UNITED STATES PATENT AND TRADEMARK OFFICE

APPLICATION NO.	FILING DATE	FIRST NAMED INVENTOR	ATTORNEY DOCKET NO.	CONFIRMATION NO.
10/594,849	04/02/2007	Hans-Georg Brauer	628/08	3648
27538 7590 07/17/2009 GIBSON & DERNIER L.L.P. 900 ROUTE 9 NORTH SUITE 504 WOODBIDGE, NJ 07095				
EXAMINER				
KELLER, MICHAEL J				
ART UNIT		PAPER NUMBER		
3634				
MAIL DATE		DELIVERY MODE		
07/17/2009		PAPER

Office Action Summary

DETAILED ACTION

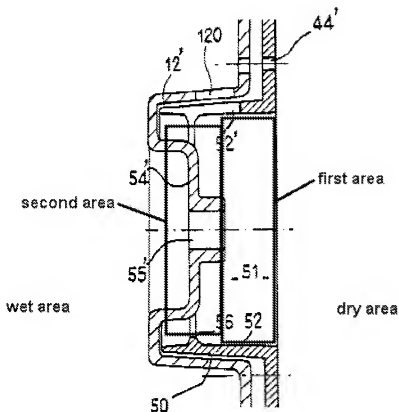
11. **Claims 1-6, 8-13 and 15 are rejected under 35 U.S.C. 102(b) as being anticipated by Velthaus et al. (US 6,574,922).**

12. Regarding **claim 1**, Velthaus discloses a drum housing comprising: a mounting area; a first area of the mounting area having a first diameter; and a second area of the mounting area having a second diameter as shown in the figure below. Examiner notes that no cable drum has been claimed, and the diameters of the first and second areas are sufficient for mounting a cable drum which has been properly sized to fit within the areas.

16. Regarding **claim 6**, the first diameter is greater than the second diameter as shown in the figure below.

17. Regarding **claim 8**, Velthaus discloses a door module comprising: a carrier part 20; a drum housing mounting area; a first area of the mounting area having a first diameter; and a second area of the mounting area having a second diameter as shown in the figure above. Examiner notes that no cable drum has been claimed, and the diameters of the first and second areas are sufficient for mounting a cable drum which has been properly sized to fit within the areas.

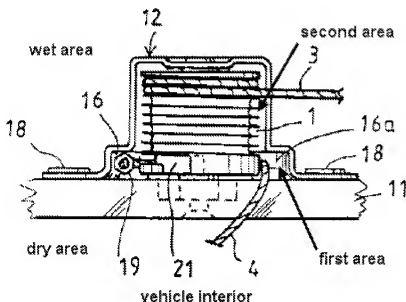
20. Regarding **claims 11 and 12**, the carrier part divides the door interior into a wet area and a dry area as shown in the figure above, and the second area faces the wet area.

21. Regarding **claim 13**, the first diameter is greater than the second diameter as shown in the figure above.
22. Regarding **claim 15**, Velthaus discloses a door of a motor vehicle comprising: a door module (Fig. 1); a drum housing 50 having a mounting area; a first area of the mounting area having a first diameter; and a second area of the mounting area having a second diameter as shown in the figure above. Examiner notes that no cable drum has been claimed, and the diameters of the first and second areas are sufficient for mounting a cable drum which has been properly sized to fit within the areas.
